**LOWER LAKE NIMHAM DAM
PUTNAM COUNTY, NEW YORK**

**PHASE I INSPECTION REPORT
NATIONAL DAM SAFETY PROGRAM**

CONTRACT NO. DACW 51-78-C-0035

PROPOSED DAM
LOWER LAKE NIMHARD
TOWN OF KENT PUTMAN CO. NY
 Scale As Noted
 FEB. 1955

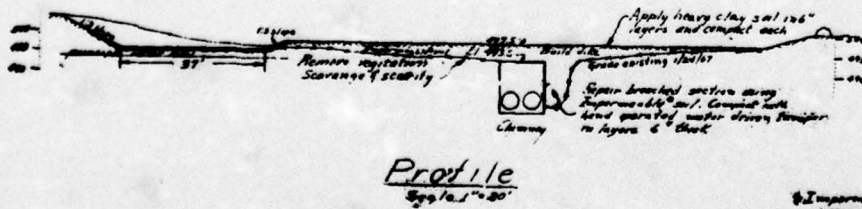
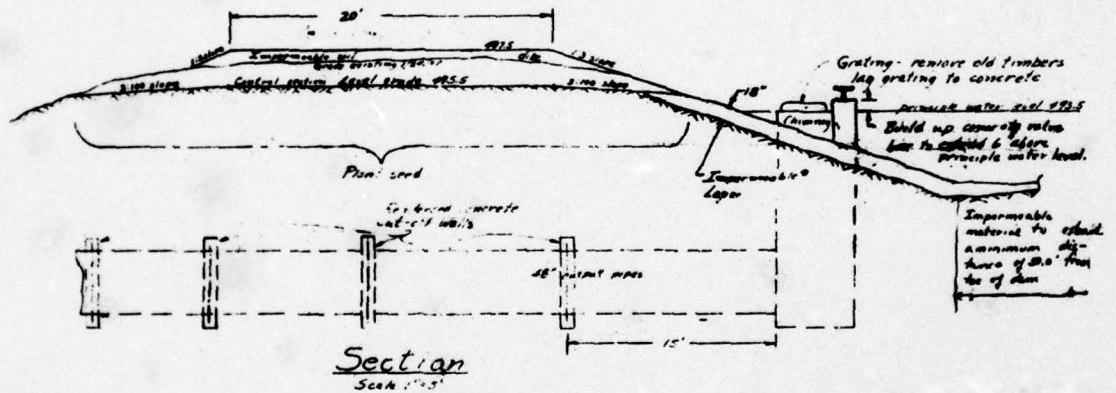
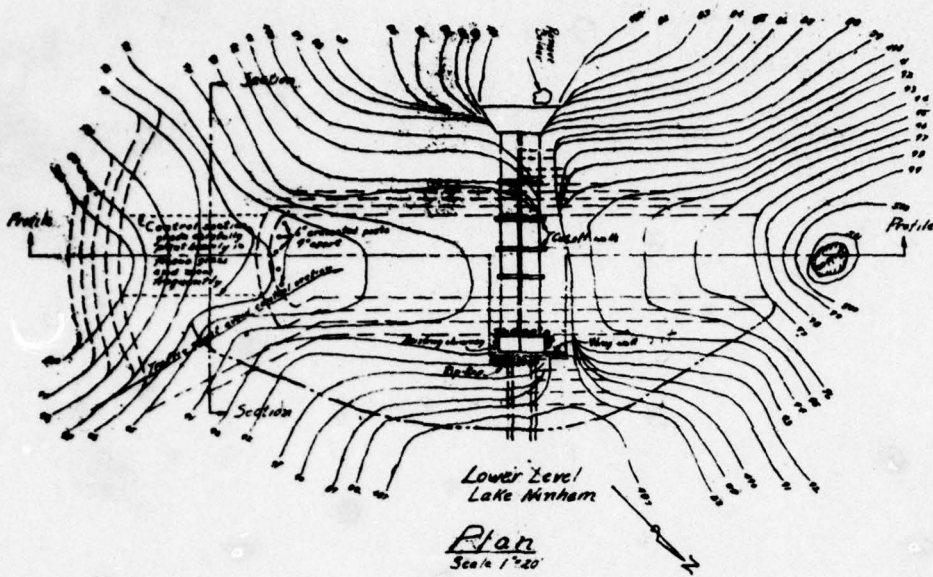
From the data which you sent us, we are unable to determine just how much of the dam is to be rebuilt or whether the entire dam is to be reconstructed as a new structure. At any rate, we would like to have incorporated in the plans the following:

1. The concrete pipes should be laid on undisturbed earth and not on a fill as shown on Section A-A of the plans.
2. There should be concrete snap-collars around the concrete pipes as indicated in red on Section A-A, constructed after the pipes are in place.
3. If the inlet structure is to be rebuilt the horizontal steel reinforcement should be as indicated in red on the plan of the inlet using the same size bars as shown on Section B-B.
4. There should be a note on the plans to the effect that the fill around the pipes should be placed in horizontal layers not to exceed 4" in thickness and that extreme care should be taken to secure tight contact between the fill and the surface of the conduits, collars, inlet structure, and headwall, by means of adequate tamping.

We submit herewith three prints of the drawing covering the above dam which has been revised in accordance with your letter of July 14, 1955.

The inlet structure was not damaged and is in good condition. Therefore, we have not shown the change requested under item #3 of your letter.
